Mandatory Referral

MR-1400F

Application	General Data	
Project Name: University of Maryland-Edward St. John Learning and Teaching Center (ESJ-LTC) Location: University of Maryland at College Park Applicant/Address: Same as above Property Owner: University of Maryland Board of Trustees	Planning Board Hearing Date:	04/3/14
	Date Accepted:	02/12/14
	Mandatory Action Timeframe:	60-Day Review
	Acreage:	2.5 acres
	Zone:	R-R
	Planning Area:	66
	General Plan Tier:	Developed Tier
	Council District:	District 3
	Adjacent Municipality:	College Park

MR-1400F Staff Report – University of Maryland - Edward St. John Learning and Teaching Center (ESJ-LTC)

ESJ-LTC PROPOSED SITE PLAN

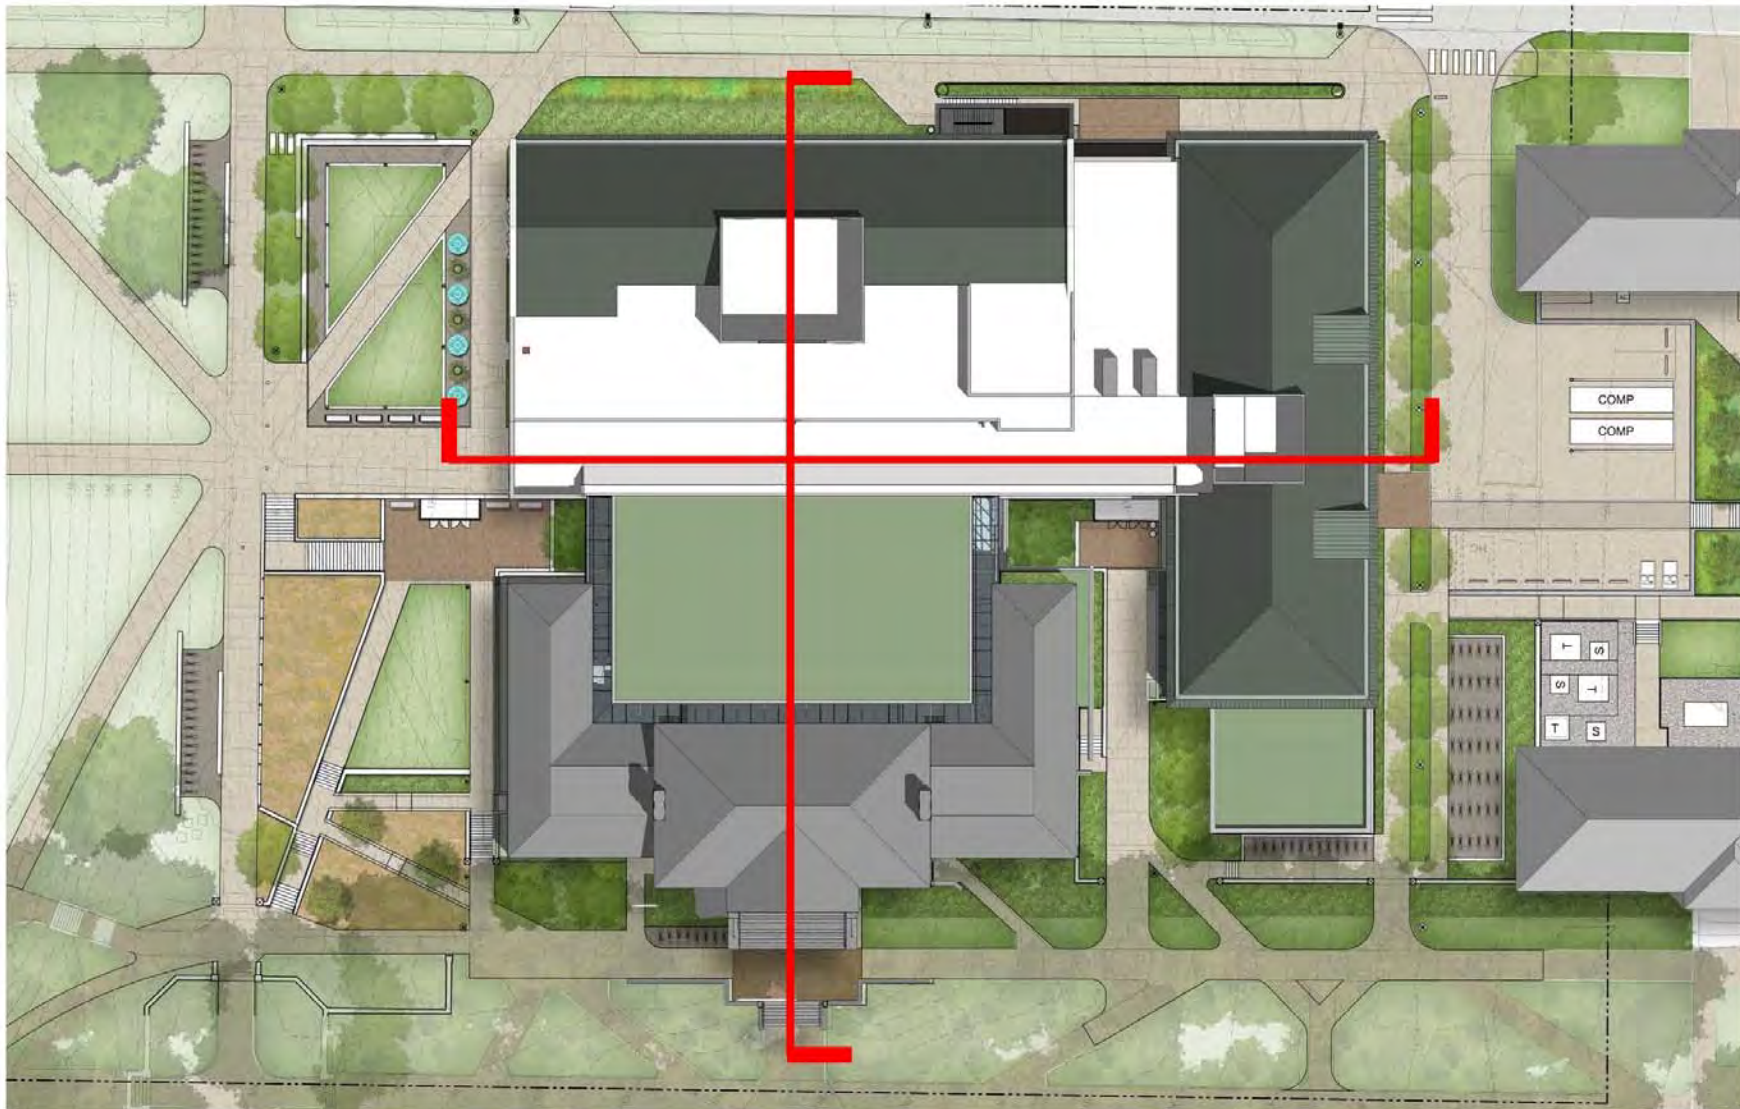
3. The University should increase the tree canopy on campus to provide visual relief. The possibility of additional shade tree plantings to the north and west of the proposed building should be explored.

4. The University should evaluate the future pedestrian circulation routes to the west and south of the building complex to further provide visual relief from large expanses of pavement by reducing widths of the proposed sidewalks and eliminating duplicate paths where possible. Consider the incorporation of pervious specialty pavers to relief from a large expanse of paving and to reduce impervious surface on the provide site.

PROPOSED ESJ-LTC SIDE/FRONT VIEW ELEVATIONS

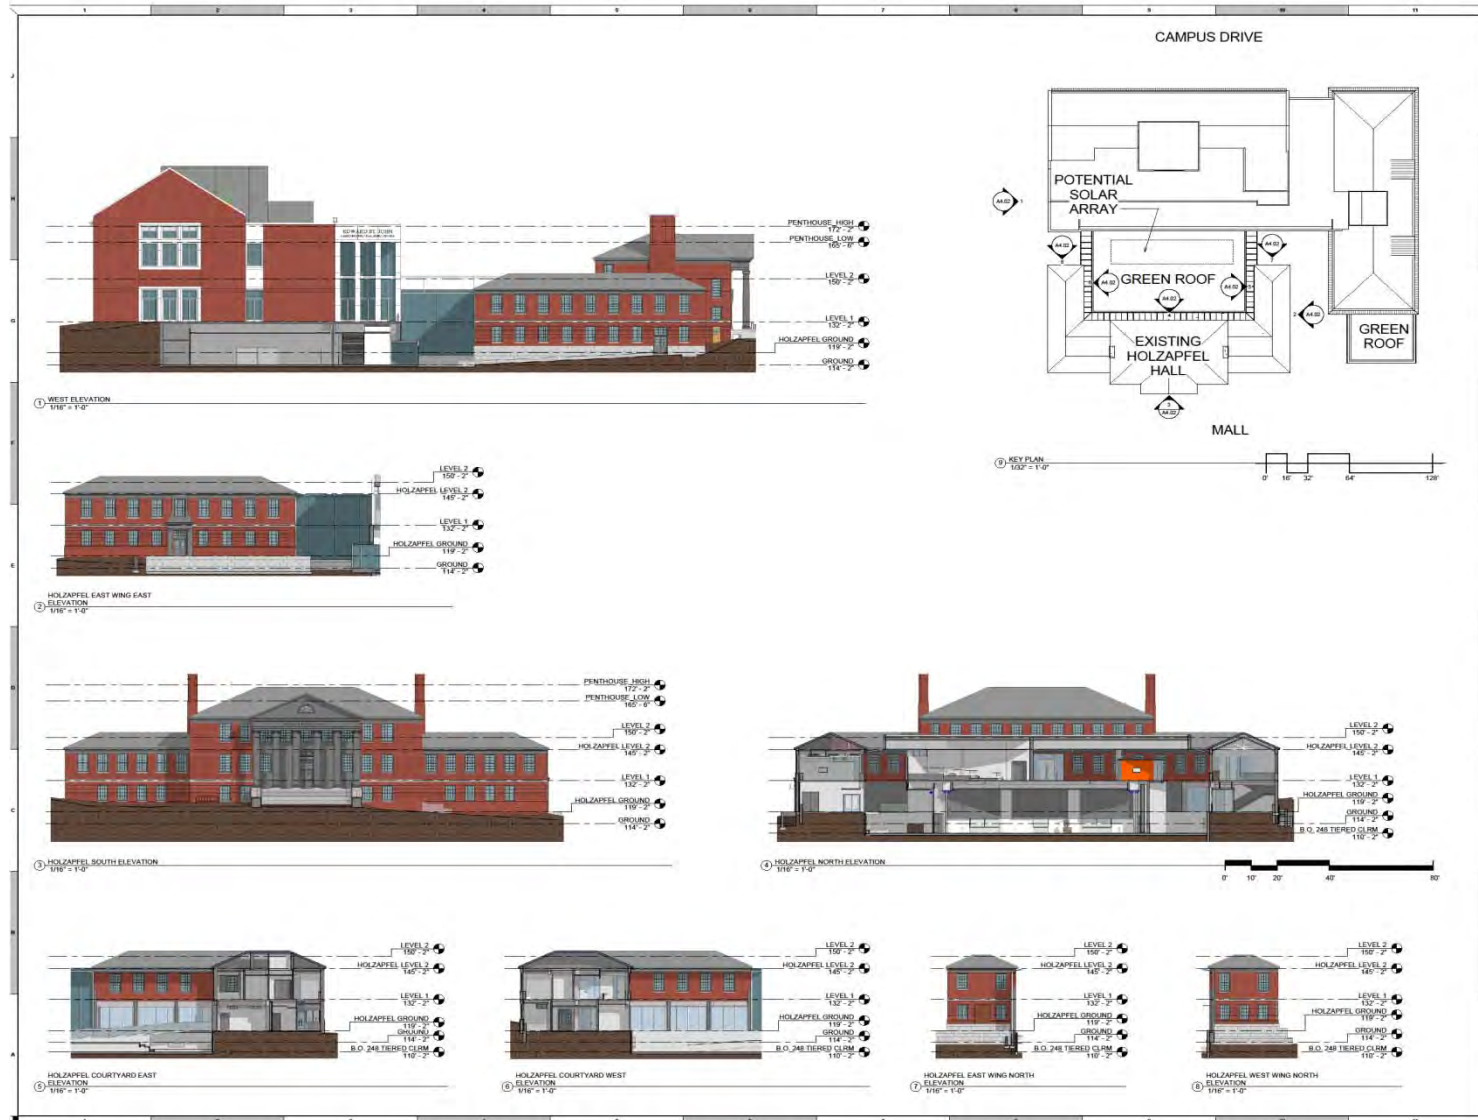
5. The University should explore the option of preserving the large, 52-inch diameter shade tree to the west of the southern portion of Symons Hall.
6. The University should revise the architectural elevations to specify the materials to be used, which is necessary, in order to get a complete analysis of the proposed architecture. While the elevations submitted for review include a number of windows that allow natural light into the new building, architectural detail is almost absent from the overall architecture of the new building. It is highly recommended that the proposed building's architecture be in line with other collegiate buildings on the University of Maryland Campus with respect to the following specifications:

- Architectural elements should be added to the roof, such as dormers and cross gable.
 - Detailing such as quoins and columns, should be utilized for the entrance areas.

- Windows should be detailed with shutters, decorative trim, and prominent sills and decorative heads.
7. The University should re-submit the revised architectural elevations for staff to review at the Administrative level.
